Responses to Peter Wilcock's Comments Made October 12, 2016 on WEST Draft Report from July 27, 2016

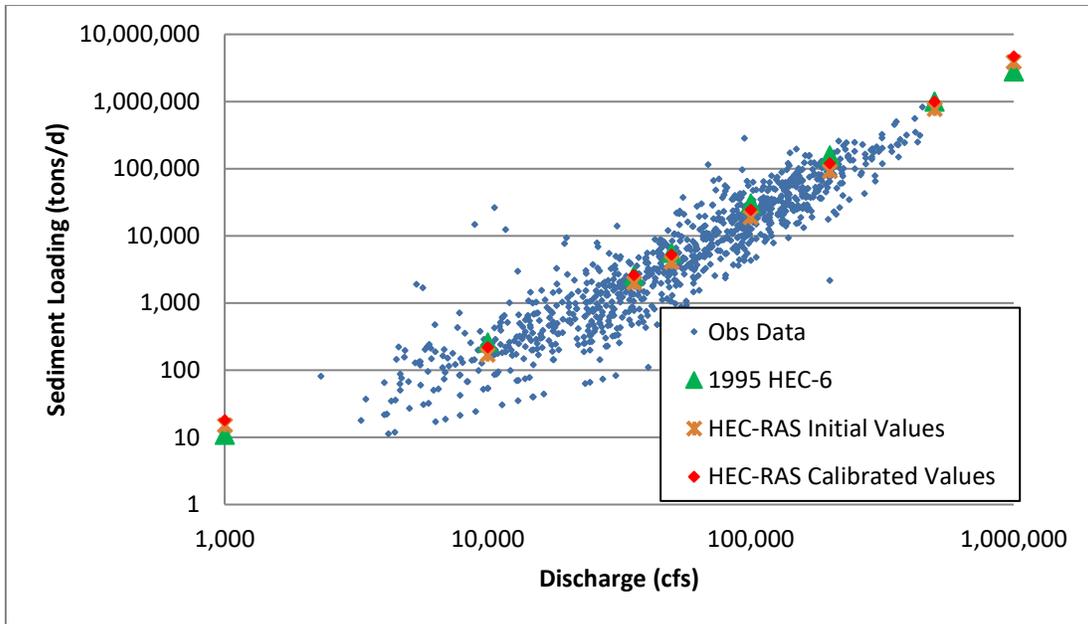
Comment: A better explanation is needed for some of the calibration adjustments discussed in the text:

“Overall, the model initially under predicted deposition for the system as a whole, though results varied by sub-area. To increase deposition, the sediment loading at Marietta was increased by 20-30% at various flows. This resulted in loading values still well within the range of scatter in the observed loading, and matched the HEC-6 input values (Hainly, et al., 1995) very closely for several flows.”

prw: Although within the range of scatter, not all changes to the sediment loading may be plausible. A plot of the Marietta sediment loading actually used would be useful for review.

Response: The report draft was updated to reflect this suggestion. The scatter plot showing the rating curve fit to the observed data was moved from the model development section to the calibration section (3.2.3), and the highlighted sentences were added to the paragraph in question:

“Overall, the model initially under predicted deposition for the system as a whole, though results varied by sub-area. To increase deposition, the sediment loading at Marietta was increased by 20-30% at various flows. This resulted in loading values still well within the range of scatter in the observed loading. Figure 3.9 shows a logarithmic plot of sediment load by discharge at Marietta, and presents a comparison of the final rating curve used in the calibrated model with the initial rating curve fit to the observed data and the rating curve used in the HEC-6 model by Hainly et al. (1995).”

The final loading values are included in Appendix B; we feel these together provide adequate explanation.
